DELEGATED APPLICATION REPORT

SITE ADDRESS: Forbury Park, Kenavon Drive, Reading, RG1

APPLICATION NUMBER: PL/25/0639

PROPOSAL: Retrospective temporary use of vacant land for public car parking (Sui Generis)

Layout plan submitted by the applicant on 04/06/2025

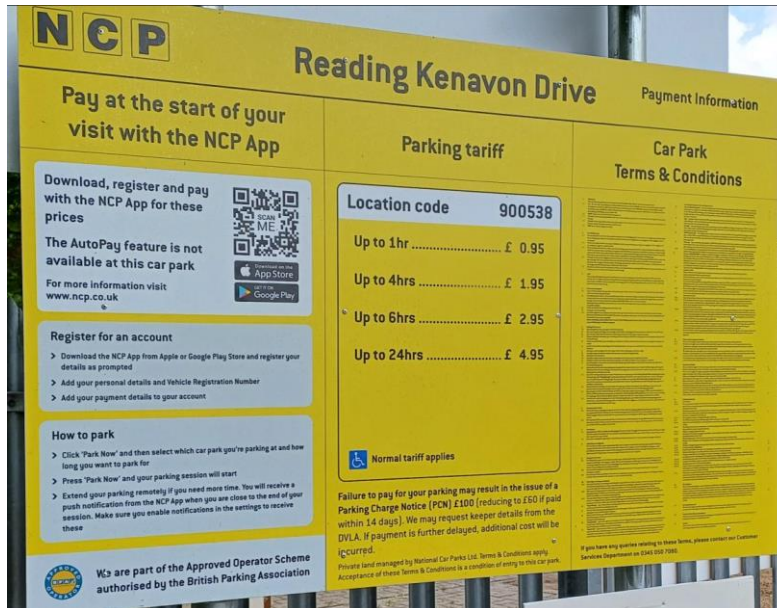
- 4.1.6 In terms of access and layout, the car will utilise the existing access point from Kenavon Drive. All spaces comply to the dimensions of 2.5m x 5m. However, some spaces have less than the recommended 6m forecourt and it may not be possible to provide for vehicles to get into the spaces in one movement. Some back and fore manoeuvring may be required which is acceptable where traffic volumes and speeds are low. Given the temporary nature of the application, the access and layout is considered acceptable. However, no directional signage or markings within the car park has been illustrated on the proposed site plan to ensure that priority movement is given to vehicles entering the site. I am happy to deal with this by condition or by amended plan.

- It is noted that only a single entry point into the site is proposed. As this access point will remain open at all times and will not be secured, I have concerns regarding personal safety and vulnerability to crime for car park users. The absence of an alternative means of entry or egress means that, should the primary route become compromised or obstructed, users would have no other safe means of escape, thereby increasing their exposure to potential criminal activity. An additional pedestrian entrance (in a different location to the main entrance) should therefore be provided. This would need to be covered by CCTV (more below). I would also suggest that the surrounding hedgerow vegetation is reduced in height, so that its defensive qualities are maintained, but allows views into the car park when approaching from the street. A vehicle barrier at the entrance to the site is recommended – whilst it is noted that certain types of barrier can easily be lifted out the way, a barrier would provide additional protection from car theft and provide a visual demarcation of private space, thus modifying people's actions.

- The quality of the information provided does make it difficult (case officer clarification: to assess the proposals), and the reference to a gate is misleading. (case officer clarification: the titles of the documents submitted reference gates, but no gates are shown)

- The general location of the pedestrian access is ok, but it's proposed position next to a tree will potentially obscure views and effect coverage of the entrance by CCTV and lighting. Therefore the access should be moved a further c.5-10m east along the boundary so good surveillance of it can be achieved. I also believe that bollards or chicane barriers to restrict vehicle entry here will be required and should be added to the details submitted, or required through condition.

- As mentioned previously, it will be important to ensure that the boundary vegetation around the car park is cut back to approximately 1m in height to ensure there are views into and out of the car park. This is particularly key around this pedestrian entrance – can a condition be added to ensure that the boundary vegetation is maintained to a suitable height?

Within 4 (four) weeks of the date this application is permitted, a plan showing how at least 3 (three) accessible parking spaces can satisfactorily be provided on site shall be submitted to for approval in writing by the Local Planning Authority. The vehicle parking spaces shall be provided in full accordance with the subsequently approved details within 4 (four) weeks of written approval being given and thereafter be kept free of obstruction and retained in accordance with the approved details, and shall remain available for the parking of vehicles at all times.

Within 4 (four) weeks of the date this application is permitted, full details of the direction signage and markings within the car park area, based on 'Proposed layout plan, as received 04/06/2025', shall be submitted to for approval in writing by the Local Planning Authority. The approved details shall be provided in full accordance with the subsequently approved details within 4 (four) weeks of written approval being given and thereafter be maintained in good condition.

Notwithstanding the layout plan hereby approved (Proposed layout plan, as received 04/06/2025), within 4 (four) weeks of the date this application is permitted, details of a pedestrian only entry/exit point opening onto Kenavon Drive shall be submitted to for approval in writing by the Local Planning Authority. Details shall include measures to prevent vehicular use and a landscape management strategy to maintain suitable visibility. The entry/exit point shall be provided in full accordance with the subsequently approved details within 4 (four) weeks of written approval being given. Thereafter, the pedestrian entry/exit point opening shall permanently be kept free of any other obstructions, maintained in a good condition and kept open and available at all times for non-vehicular use to access and exit the car park for the lifetime of this permission.
